City of Phoenix

Staff Report: Z-10-18-8

May 1, 2018

Commercial and medical uses

Conceptual Site Plan

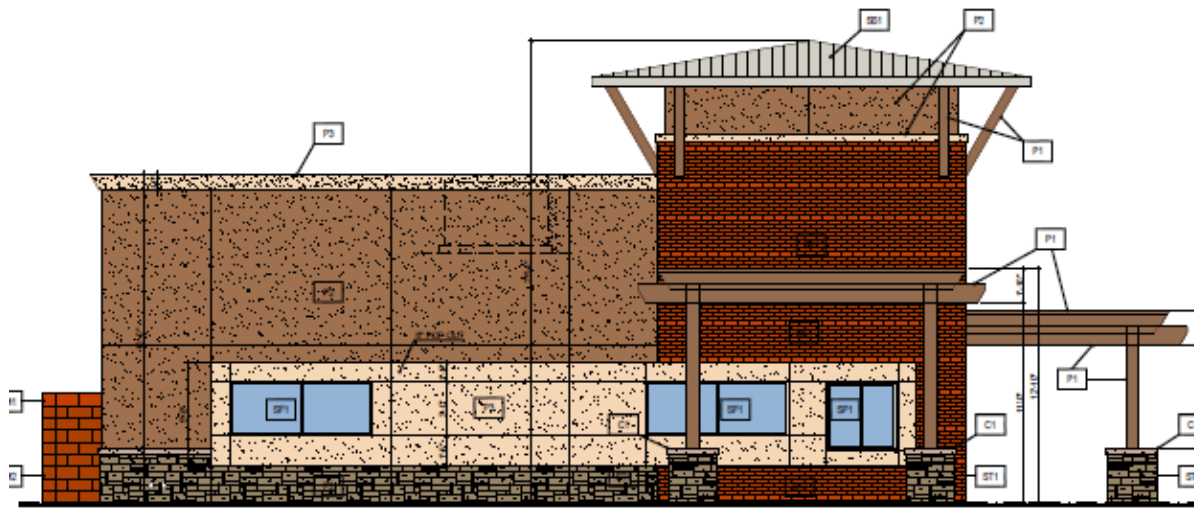
The site plan proposes west half-street improvements for 27th Street and vehicular access to the site from 27th Street at a driveway approximately 300 feet north of Baseline Road. This proposed configuration of 27th Street would maintain the existing misalignment of 27th Street across Baseline Road. However, the alignment of 27th Street would allow future consideration of a traffic signal at this intersection which would not be possible if the misalignment were to remain. Existing conditions at the intersection of 28th Street and Baseline Road are not conducive to installation of a traffic signal. Discussions between the Street Transportation Department and the applicant are ongoing to determine the feasibility of aligning 27th Street, a potential design concept for the subject site, and potential street infrastructure improvements.

The site plan also proposes relocating an existing bus stop along Baseline Road to a new location inside a deceleration lane near the southwest corner of the site. Staff does not support this proposed location as it would require that buses exit and re-enter traffic along Baseline Road. Staff recommends that this bus stop

remain in place or be relocated within the existing westbound traffic lane along Baseline Road, which would prioritize the efficient movement of public transit vehicles. Stipulation #7 requires that the final location of this bus stop be approved by the Public Transit Department.

The site plan also depicts a number of amenities along the north property line, adjacent to the Western Canal, intended to promote active uses and access to the Canal. Stipulation #2 addresses provision of and access to the amenities. Amenities include a multi-use trail or shared-use path providing connectivity to Baseline Road, a corral area with hitching posts for equestrian users, shaded benches, and bicycle parking.

7. The location of the bus stop along Baseline Road shall be approved by the Public Transit Department.
8. The developer shall construct all streets within and adjacent to the development with paving, curb, gutter, sidewalk, curb ramps, streetlights, median islands, landscaping and other incidentals, as per plans approved by the Planning and Development Department. All improvements shall comply with all ADA accessibility standards.

EXTERIOR ELEVATIONS

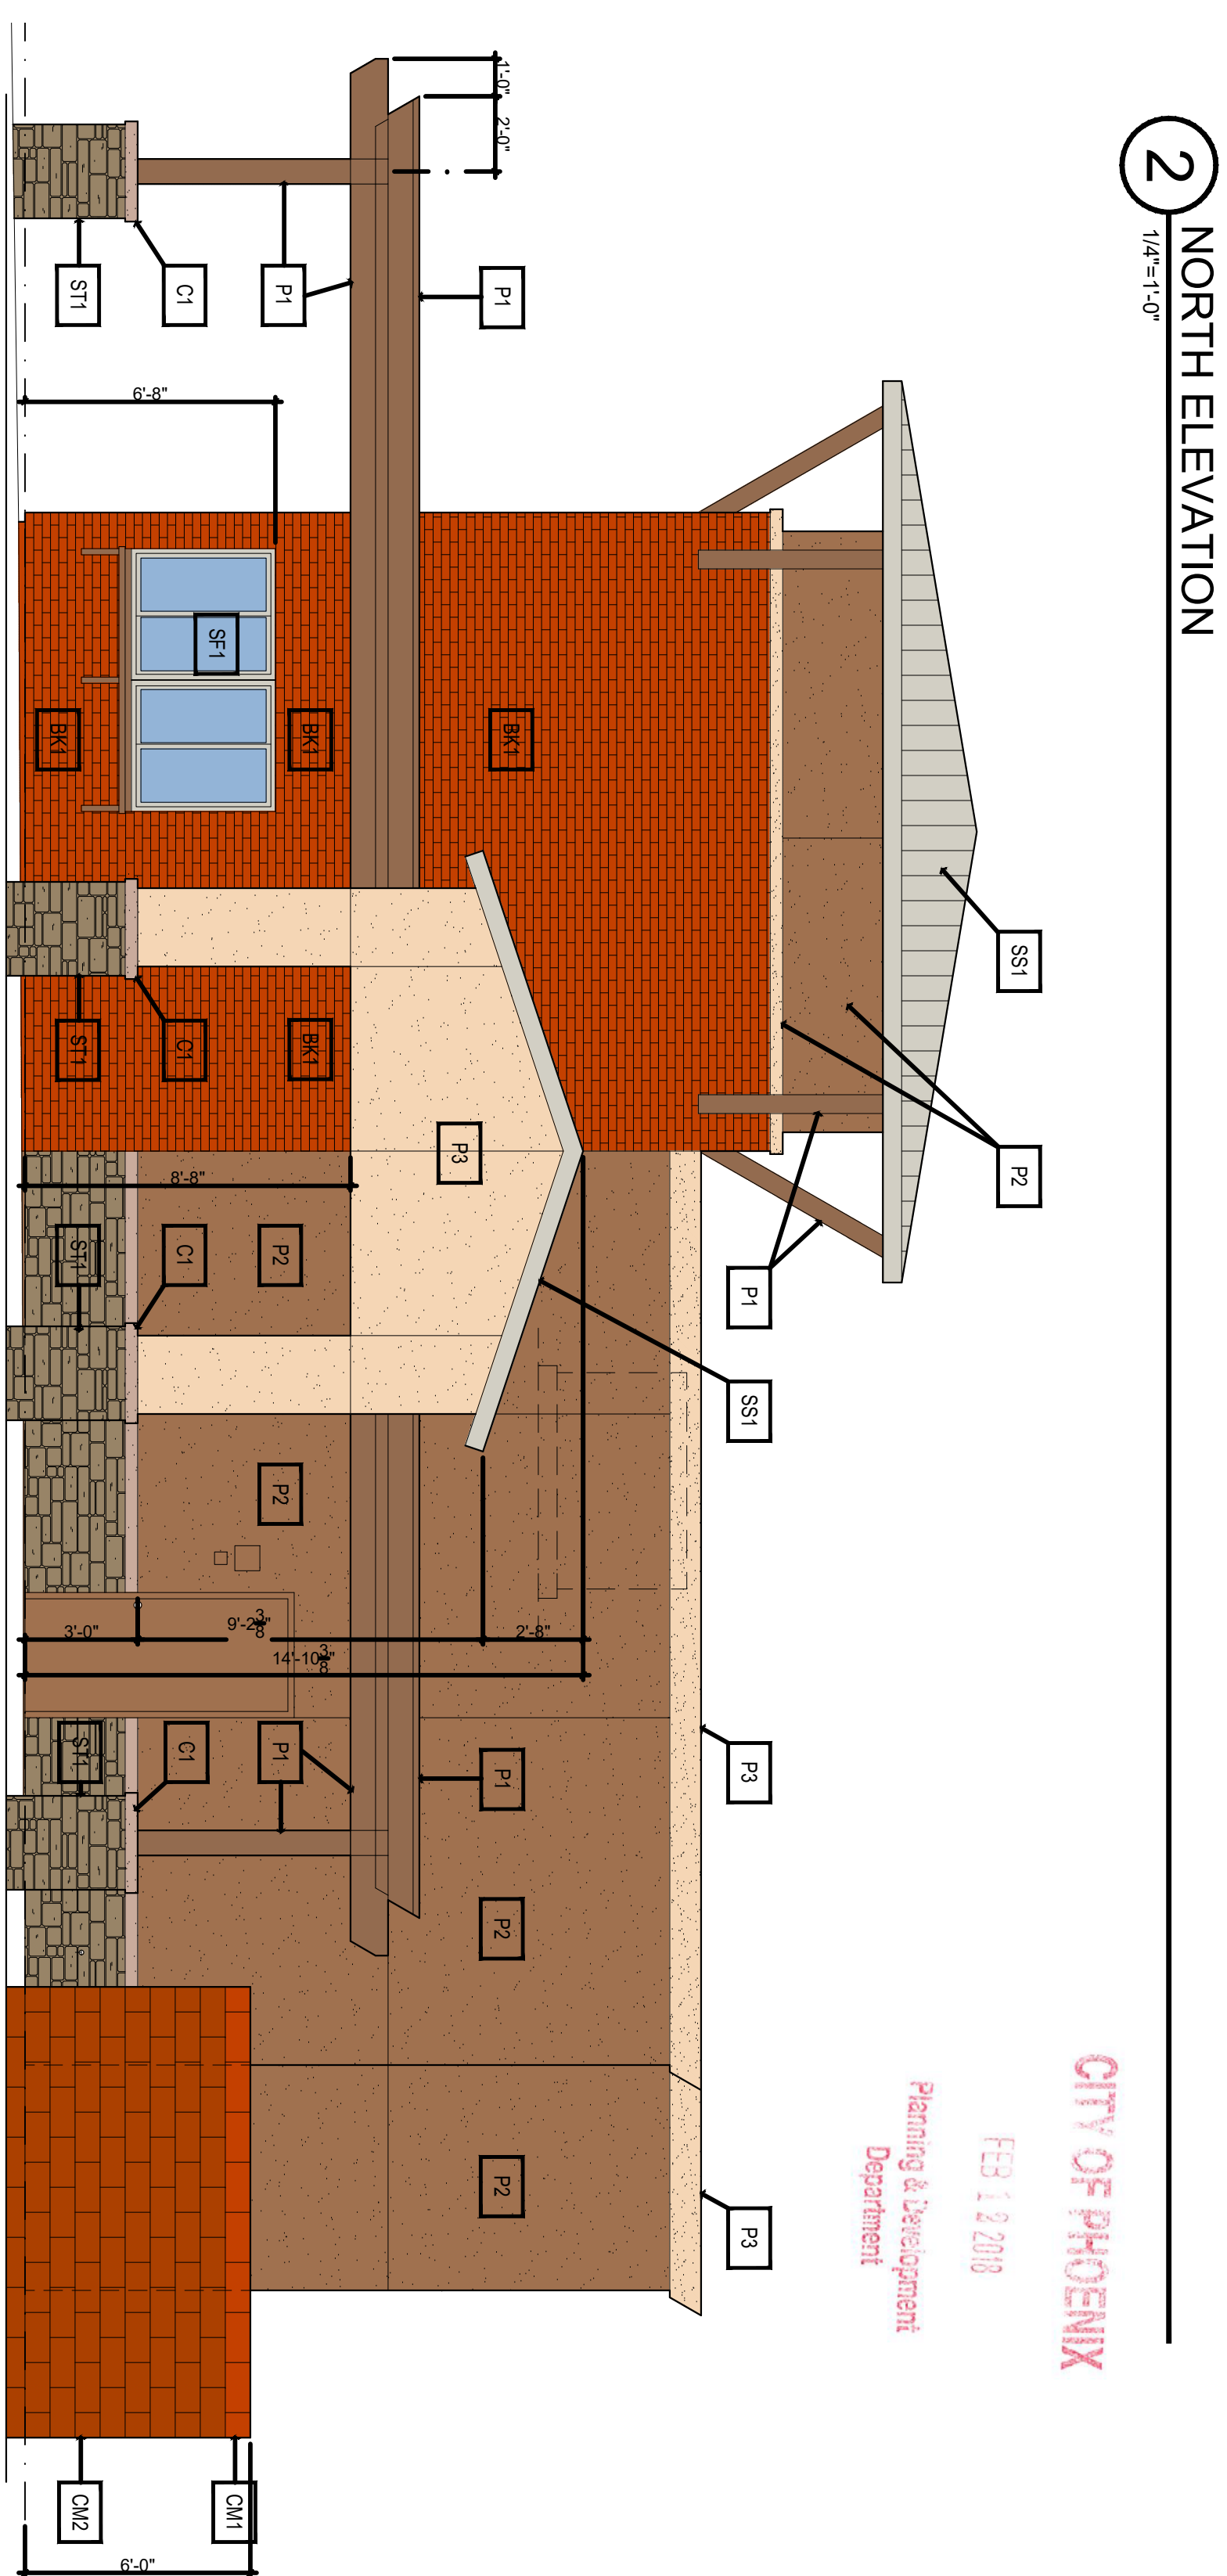
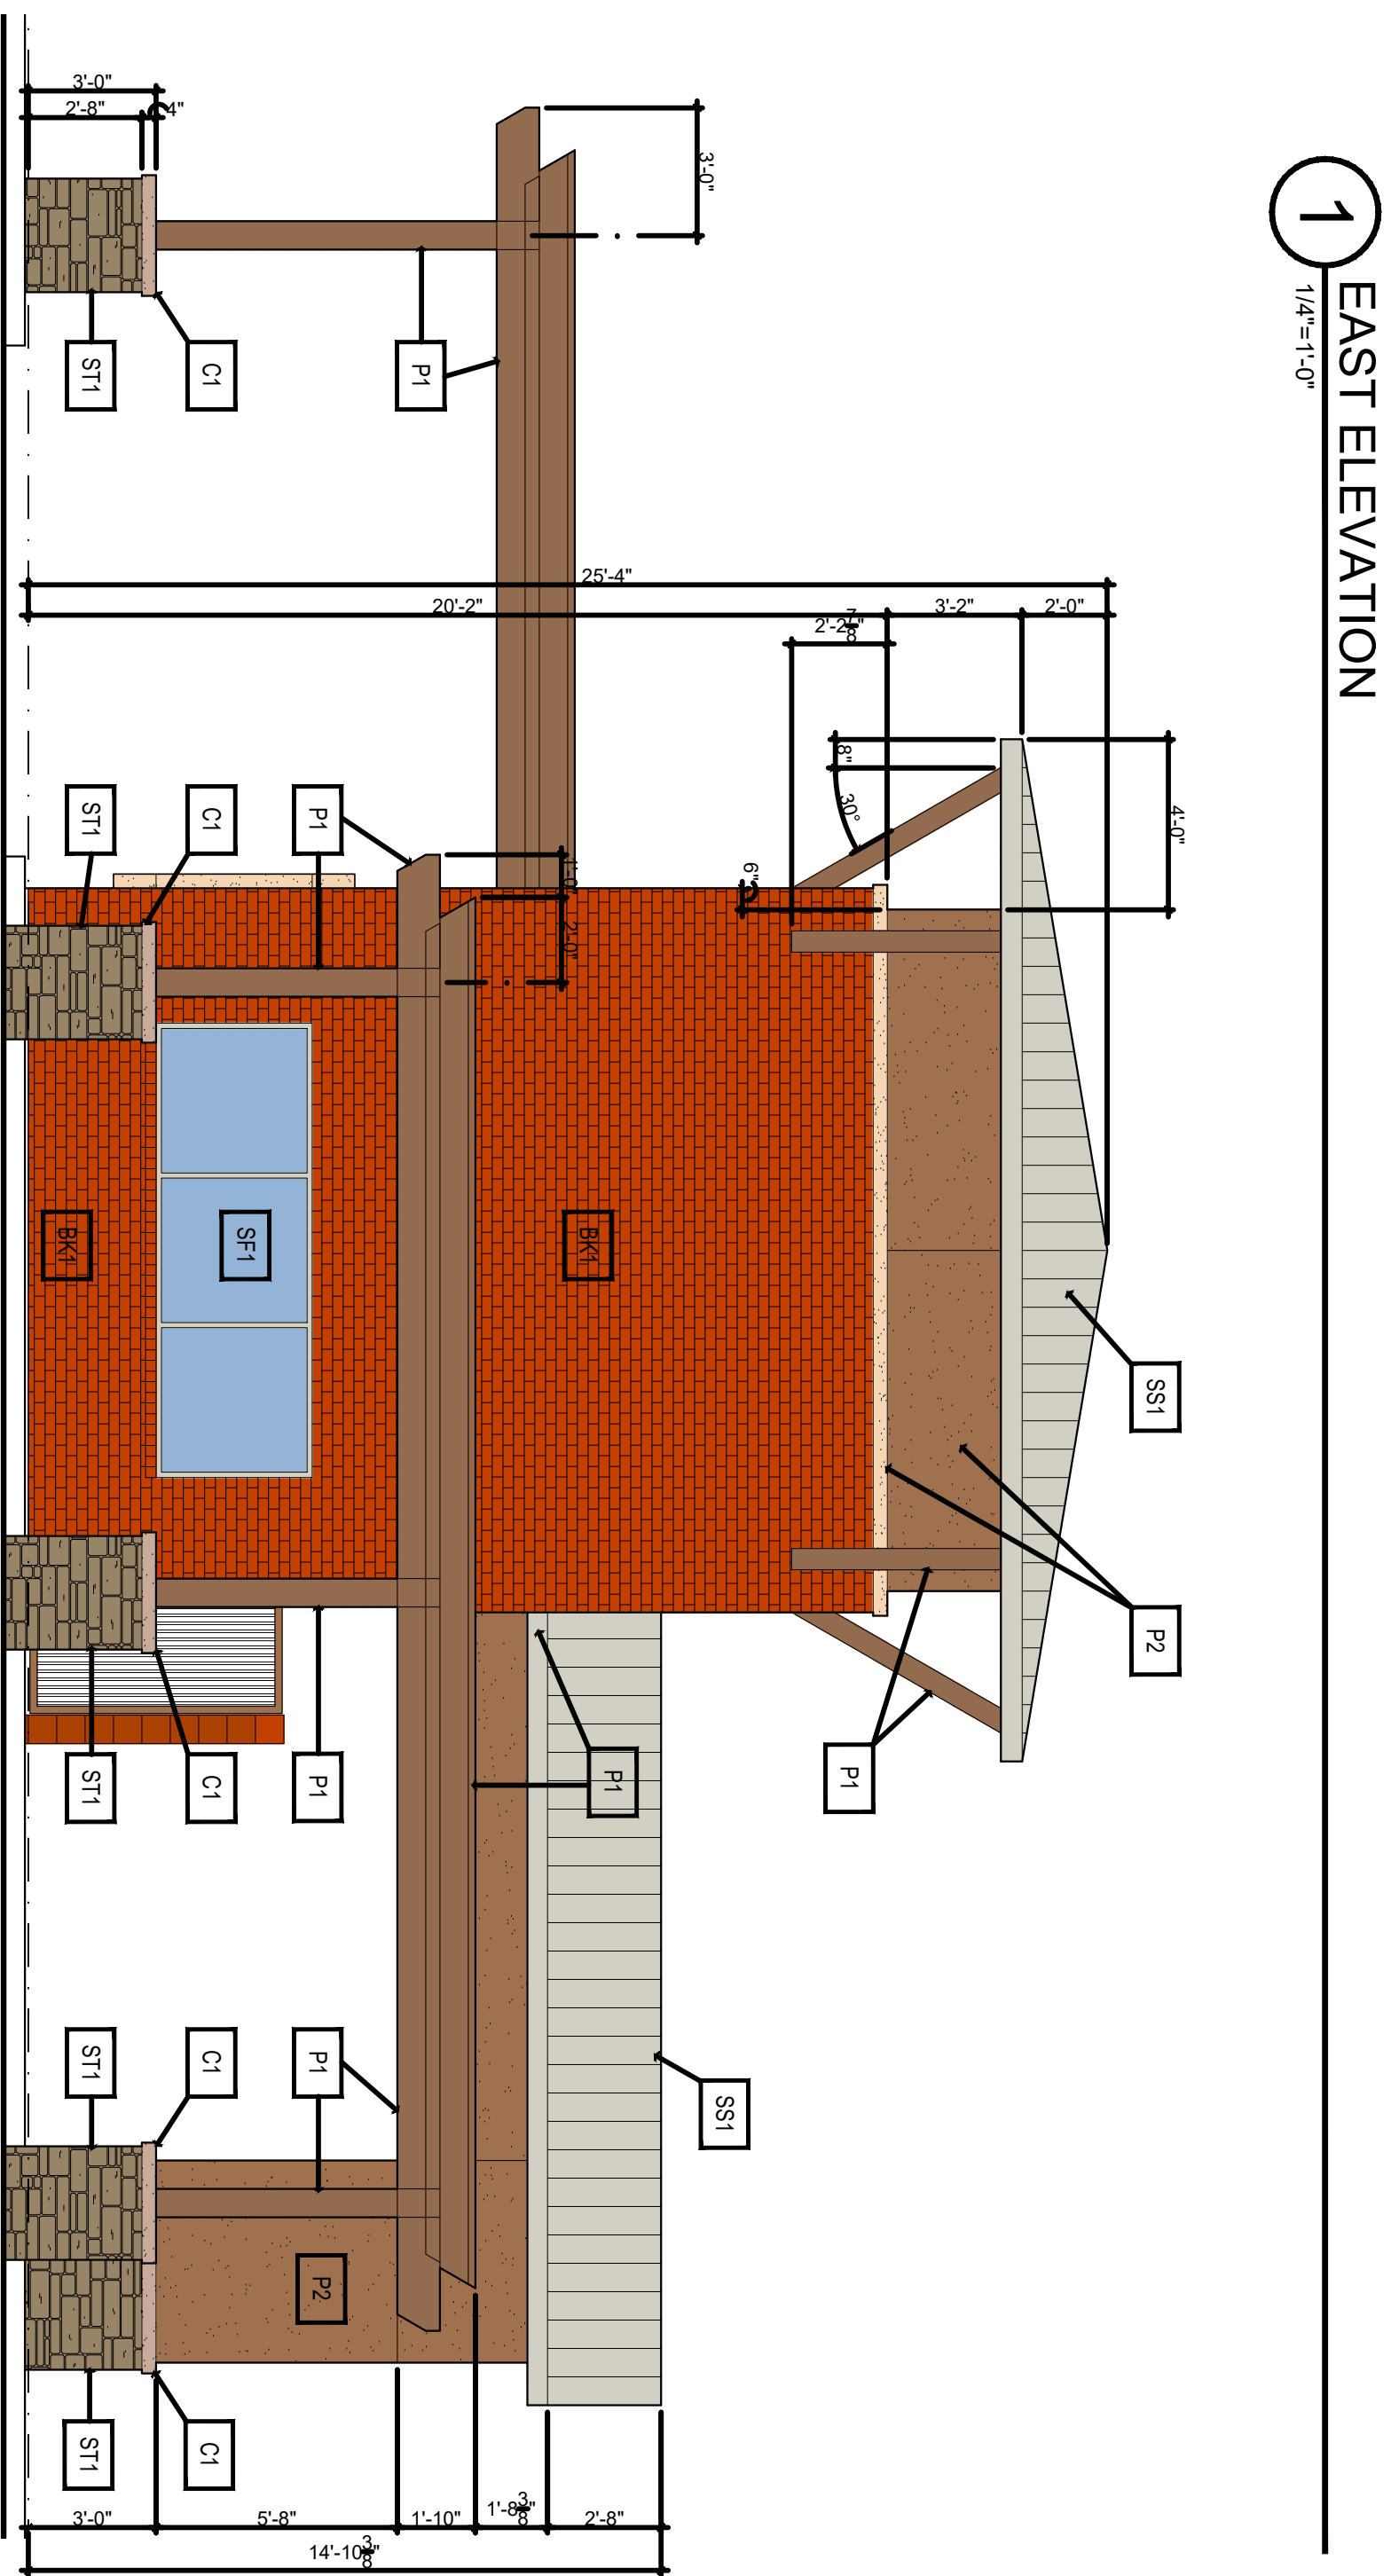
The conceptual building elevations depict a commercial drive-through restaurant at one-story and 30 feet in height. The building elevations contain a variety of building materials including cultured stone, brick, and colored concrete. Roof materials are varied and consist of wooden awnings, metal, and a variety of parapet materials and architectural features. Building colors are varied with at least four exterior colors.

- Stipulation #1 requires general conformance to these elevations.
- Stipulation #1.a. requires that pitched roof elements shall be incorporated in all buildings.
- Stipulation #1.b. requires that all building elevations, including those facing or visible from the Western Canal, contain architectural embellishments and detailing. This stipulation is intended to ensure that equal attention is paid to the elevations facing the Western Canal and visible from adjacent properties. These features may include textural changes, pilasters, offsets, recesses, variation in window size and location, and/or other overhang canopies.

1. The development shall be in general conformance with the elevations date stamped February 12, 2018, as modified by the following stipulations and approved by the Planning and Development Department:

- a. Pitched roof elements shall be incorporated in all buildings.
 - b. All building elevations, including those facing or visible from the Western Canal, shall contain architectural embellishments and detailing such as textural changes, pilasters, offsets, recesses, variation in window size and location, and/or other overhang canopies.
